DOCKET ITEM #4
Development Special Use Permit #2018-0013
Hoffman Town Center, Block 6C – 2425 Eisenhower Avenue

Development Special Use Permit #2018-0013
2425 Eisenhower Avenue

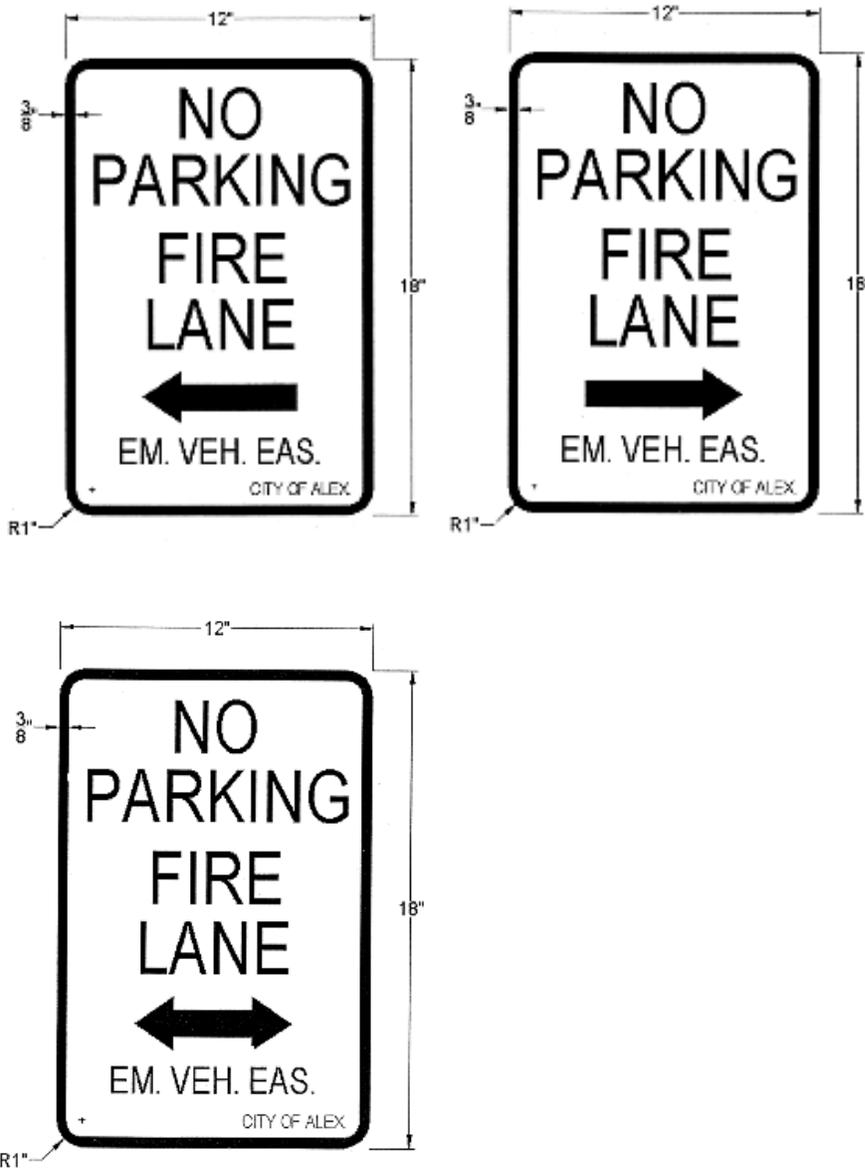
236. The site plan shall show placement of emergency vehicle easement signs. See sign detail and placement requirements are as follows:

Emergency vehicle easements shall be a minimum of 22 feet across the travel lane. The emergency vehicle easement shall provide access to strategic areas of the building and fire protection systems. Curbing and street components shall conform to the standards established by Transportation and Environmental Services and this document for emergency vehicle easements.

Example Stairway Identification Sign

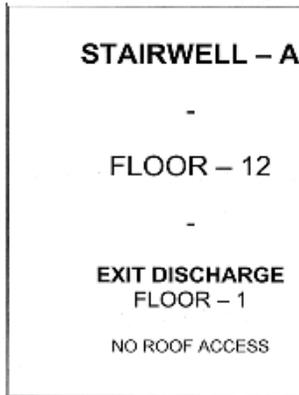
Stairway signs shall designate the stairway letter, state the floor level, the level of exit discharge, and if there is access or no access to the roof regardless if the access door or roof hatch locks. The bottom of the sign shall be located five (5) feet above the floor landing in a position that is readily visible when the stairwell door is opened or closed. The signs must have lettering that is a minimum of 2 inches but no greater than 4 inches in height. This information may be stenciled directly onto the wall but all lettering must be of a color contrasting with the background stairway wall color.

Example Building Footprint Sig

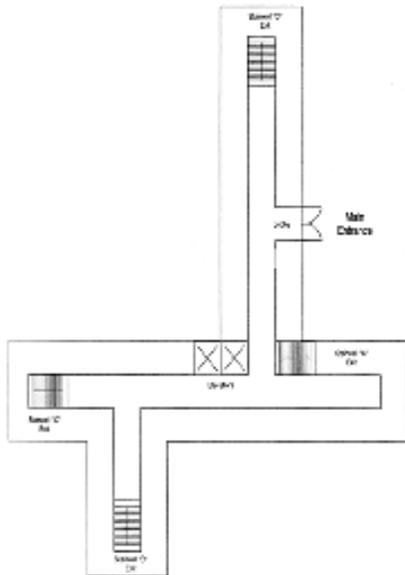
In buildings greater than three stories where there is no graphic representation of the building footprint, a simplified building schematic must be display in the lobby. The simplified building footprint shall be an overhead view of the building exterior and the general layout of the lobby of the first floor. Stairways shall be denoted by letter as required
